I object to the WestConnex M4-M5 Link proposals as contained in the EIS application # SSI 7485, for the reasons set out below.

Application Number: SSI 7485

Application Name: WestConnex M4-M5  
Link

The EIS states in 6.5.8 Darley Road civil and tunnel site (C4) that:

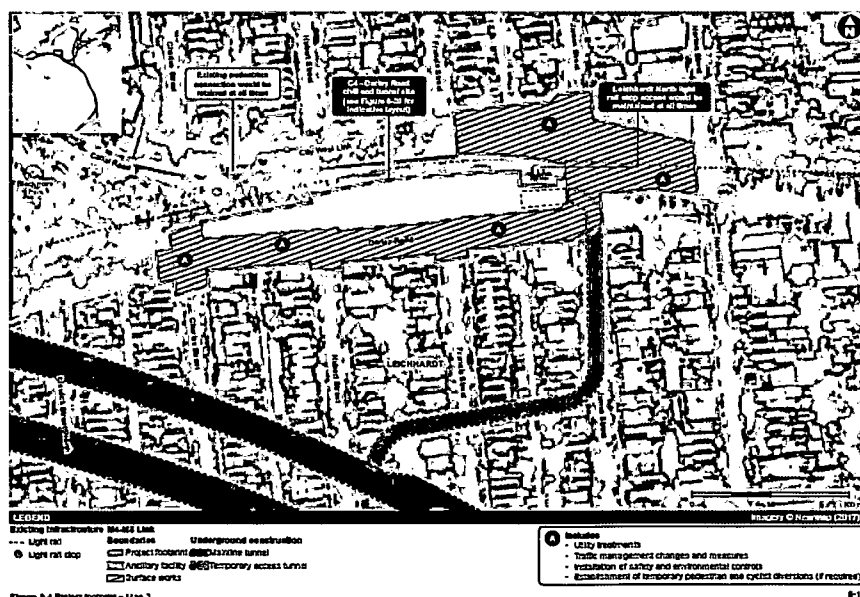
- I object** to the EIS because it fails to describe the temporary changes to Darley Road, Leichhardt to enable access to and from the ancillary facility that would likely be required in relation to the Darley Rd site and instead allows for the final plan to be decided by the contractor.

It is not clear how continued access, pedestrian and cyclist movement will be preserved and I am concerned that the impacts have not been correctly identified and assessed by the proponent.

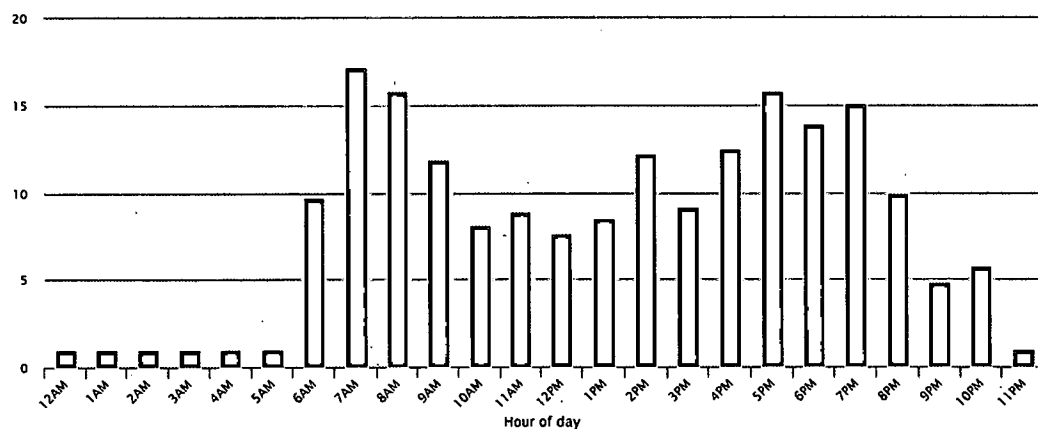
- I object to the EIS because the proponent has failed to take account of the cumulative impact of its proposed Darley Road, Leichhardt civil and tunnel site operations and the aircraft noise which the residents near the site already endure.

The attached extract from Webtrak shows that Darley Road, Leichhardt and adjacent streets are directly under the flight path.

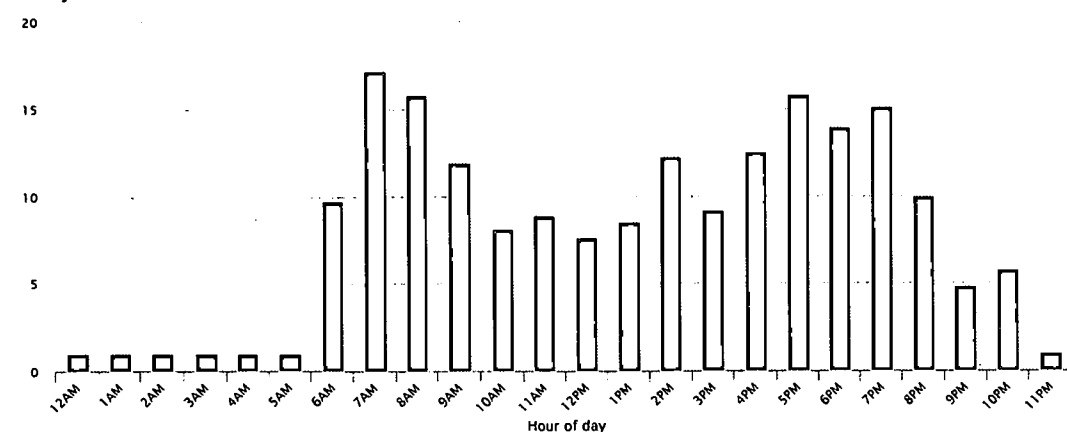
- I **object** to the EIS because the proponent has failed to take account of the cumulative impact of its proposed Darley Road, Leichhardt civil and tunnel site operations and the aircraft noise which the residents near the site already endure.

The attached extract from Webtrak shows that Darley Road, Leichhardt and adjacent streets are directly under the flight path.

#### Truck routes

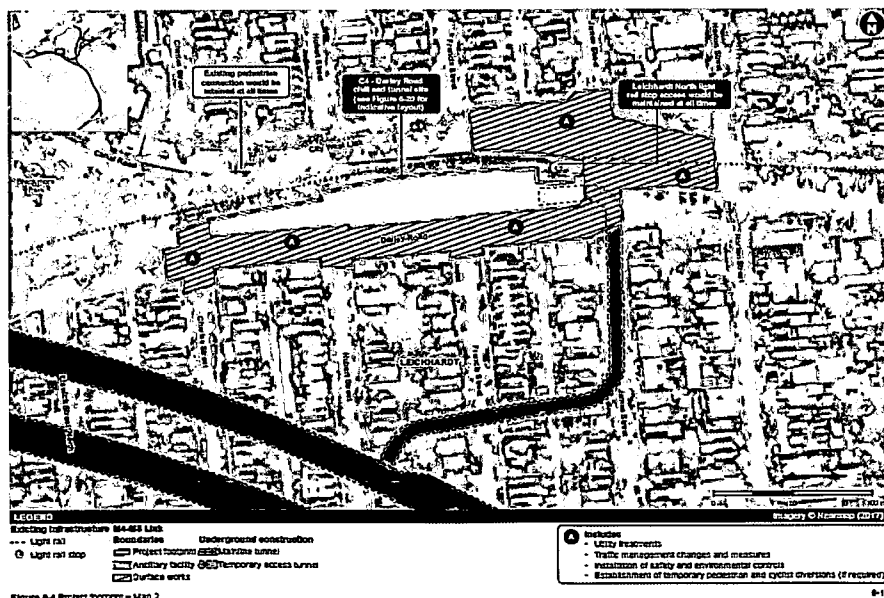
- I object to the EIS because it suggests that no local roads would be used by heavy vehicles during works yet at the same time acknowledges that spoil trucks may use local roads in exceptional circumstances which include when there is queuing to get into the site. Darley Rd is highly congested with traffic queues forming during much of the day which will lead to queues to enter the site. Queuing will not therefore be an exceptional circumstance and the result will be that spoil trucks are able to use local roads without being in breach, which will be often. This is unacceptable to residents of Francis, Hubert, William and Charles St and I object to the EIS on this basis. As queuing cannot be avoided on Darley Rd this clearly shows why this location is inappropriate. The proponent should abandon a dive site completely or find a location directly on the City West Link where spoil trucks will never use local roads. Why should residents' lives be put at risk because the project must be delivered as soon as possible?
